SYDNEY NORTH PLANNING PANEL COUNCIL ASSESSMENT REPORT

Panel Reference	PPSSNH-499
DA Number	DA2024/0499
LGA	Northern Beaches
Proposed Development	Demolition works and construction of three residential flat buildings
Street Address	<p>Lot 1 DP 213608, 120 Frenchs Forest Road West FRENCHS FOREST NSW 2086</p> <p>Lot 2 DP 213608, 118 Frenchs Forest Road West FRENCHS FOREST NSW 2086</p> <p>Lot 14 DP 25713, 11 Gladys Avenue FRENCHS FOREST NSW 2086</p> <p>Lot 24 DP 25713, 116 Frenchs Forest Road West FRENCHS FOREST NSW 2086</p>
Applicant	BMHP Group Pty Ltd
Date of DA lodgement	13/05/2024
Number of Submissions	7
Recommendation	Refusal
Regional Development Criteria (Schedule 7 of the SEPP (State and Regional Development) 2011)	General development exceeding \$30 million CIV.
List of all relevant s4.15(1) (a) matters	
List all documents submitted with this report for the Panel's consideration	<p>Architectural plans</p> <p>Statement of Environmental Effects</p> <p>Clause 4.6 Variation Request - Building Height</p> <p>Design Verification Statement</p>

Figure 3. Applicant's illustration of the proposed Building A breach of the SEPP Housing building height standard relating to the lift overrun

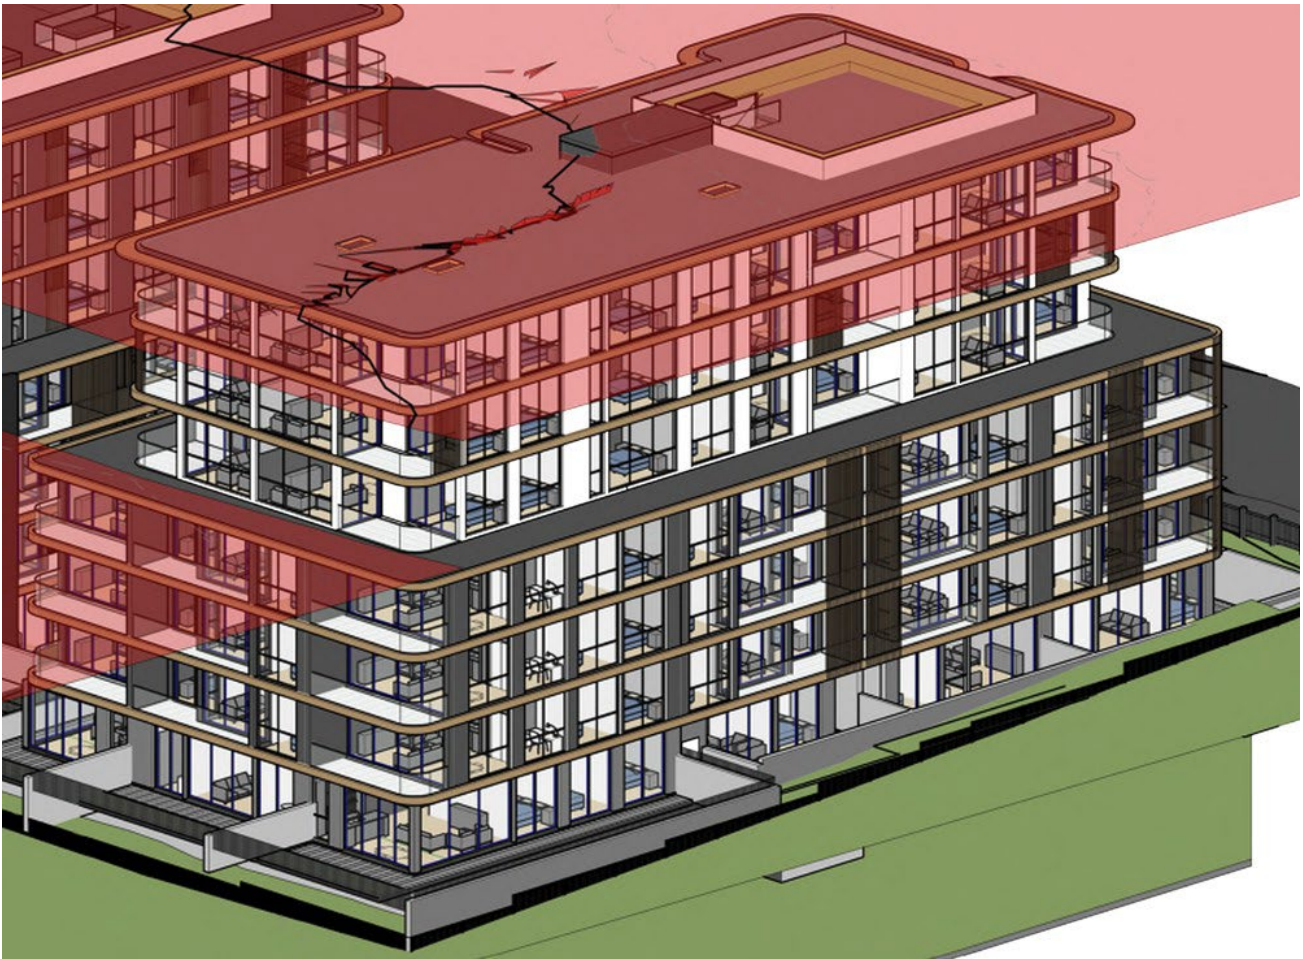
The above height plane diagrams are not certified and illustrate the extent of the breaches of the SEPP Housing building height standard, rather than the WLEP standard, so are included for illustrative purposes only. Figures 5 and 6 below illustrate Council's calculation of the proposed maximum breaches of the WLEP standard.

Figure 5. Council calculation of the proposed Building A breach of the WLEP building height standard (shaded red)

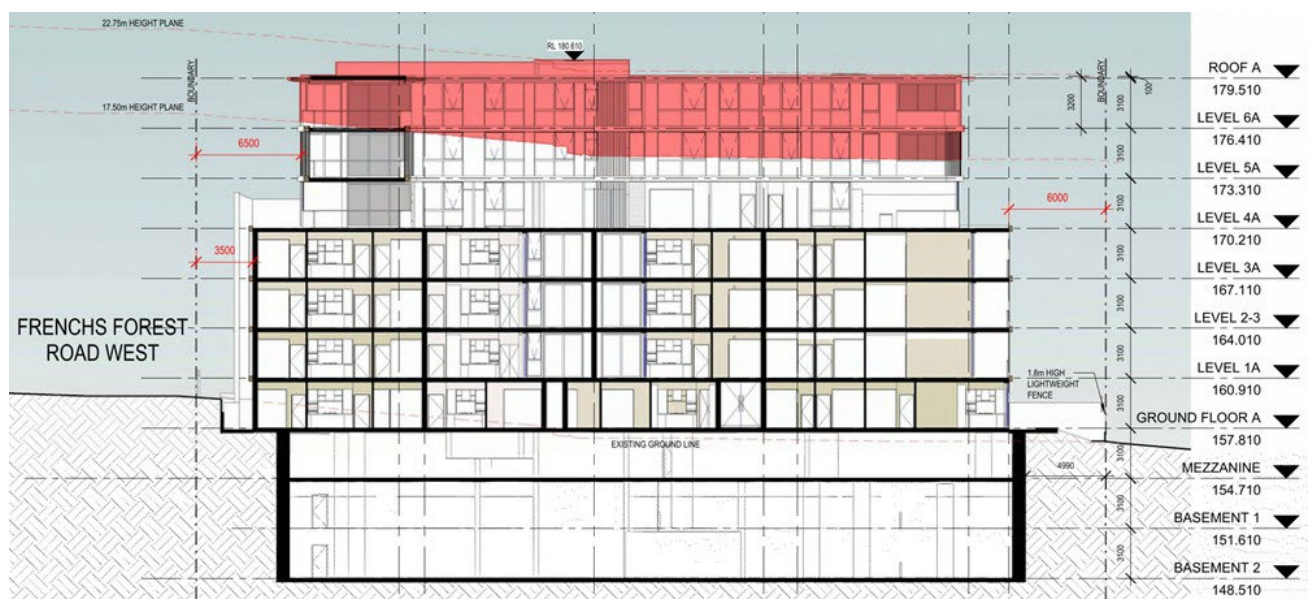
Accordingly, Council is not satisfied that the Applicant has demonstrated that there are sufficient environmental planning grounds to justify the contravention of Clause 4.3 Height of buildings.
